Re: Request for comments - proposed OPA, ZBA and CEC applications for 145 Derby Road and 3990 Rebstock Road, Crystal Beach, Town of Fort Erie

Subject: **Official Plan Amendment, Zoning By-Law Amendment, Common Element Condominium – 1st and 2nd Submission: 145 Derby Road and 3990 Rebstock Road**

145 Derby Road & 3990 Rebstock Road
Development Engineering Comments

TYPICAL URBAN ROAD CROSS SECTION
20m R.O.W.

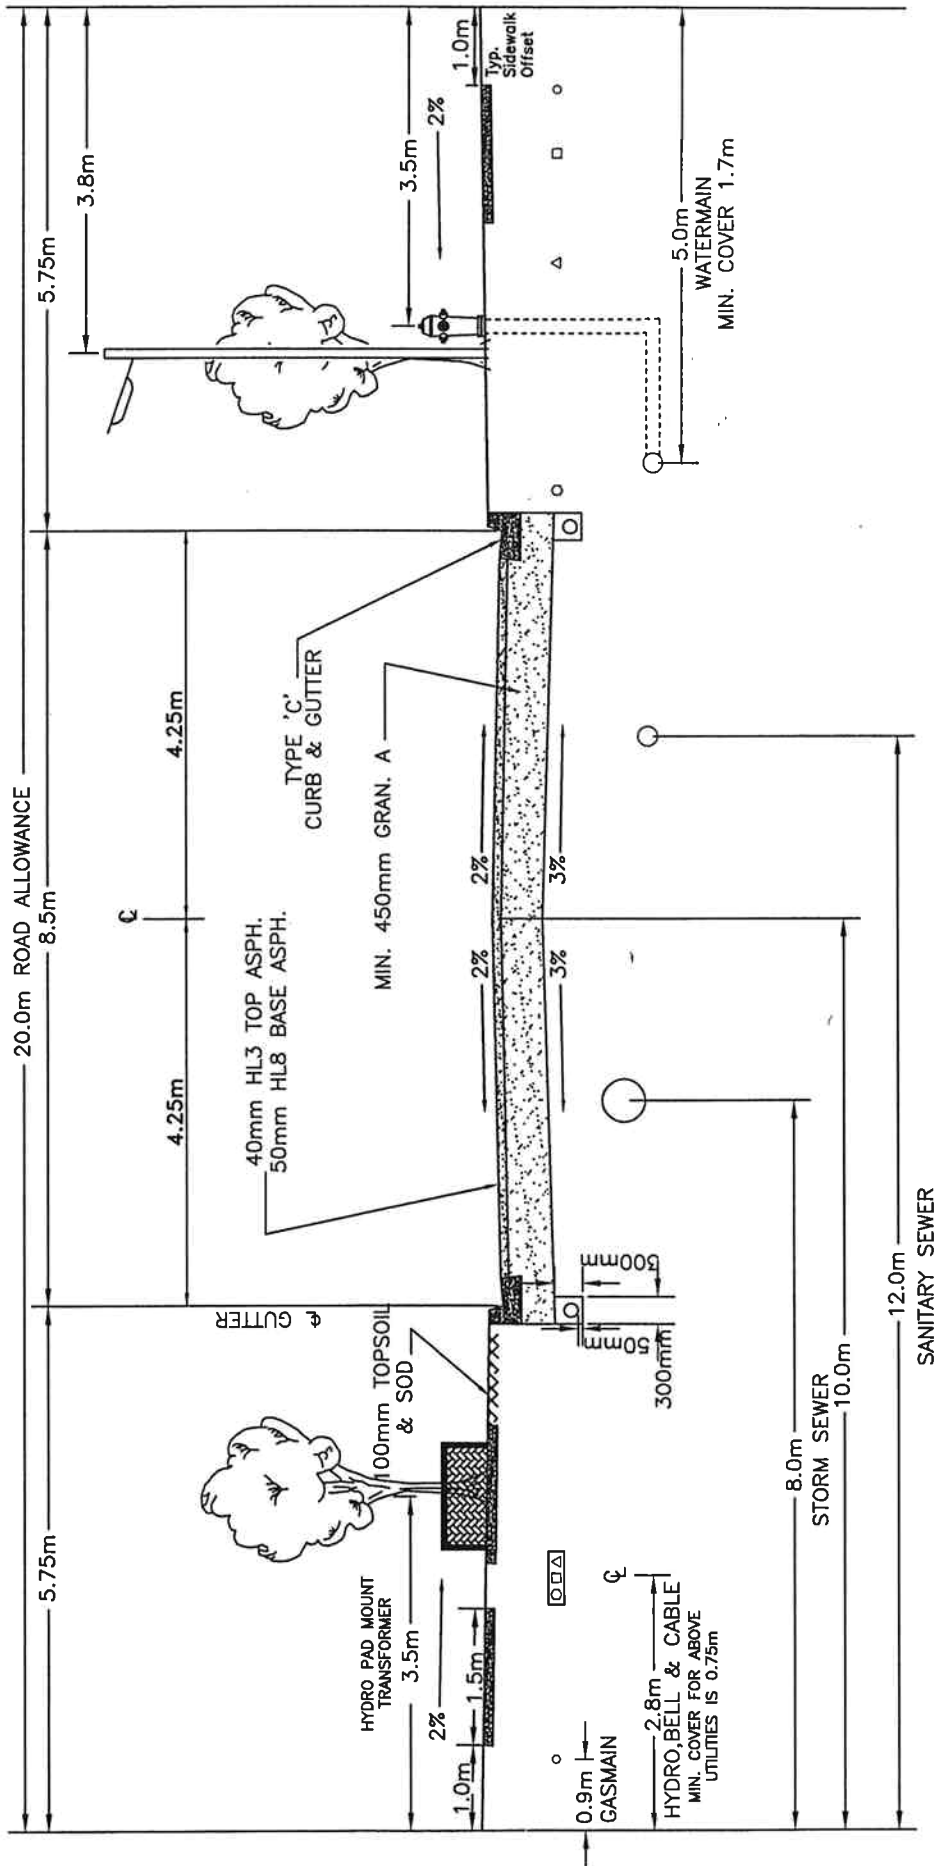
1. Since Derby Road and Rebstock Road are not constructed to the Town's urban cross section standard, and the both sections of these roads are not identified in a Development

Charge Background Study, will the Owner be required to pay for the full cost of upgrading the roads, curbs and gutters to urban standard?

2. If that is the case, will the Owner be required to upgrade both sides of the Derby Road and Rebstock Road to urban standard, or only the side along the frontage of the development?

Consistent with this policy direction, and as identified in previous Development Engineering comments, development within the urban area is expected to be serviced with an urban road cross-section, including curb and gutter and sidewalk infrastructure, in accordance with the Town's Subdivision Design Guidelines and Engineering Standards.

As Derby Road and Rebstock Road are not currently constructed to this standard, upgrades to an urban cross-section are required.

As these roads are not identified within the Town's Development Charge Background Study, the required upgrades are considered a local service and are the responsibility of the Owner, limited to the frontage of the subject lands.

For reference, a typical 20.0 m urban road cross-section has been attached.

Development Engineering is only requiring upgrades to the urban cross-section along the frontage of the subject lands, not both sides of the roadway.

Derby Road and Rebstock Road are currently in a partially urbanized cross-section on the opposite side of the roadway. As such, a full road reconstruction is not warranted at this time.

Furthermore, as these works are not identified within the Development Charge Background Study, the required upgrades are considered a local service and are therefore limited to the frontage of the subject lands.
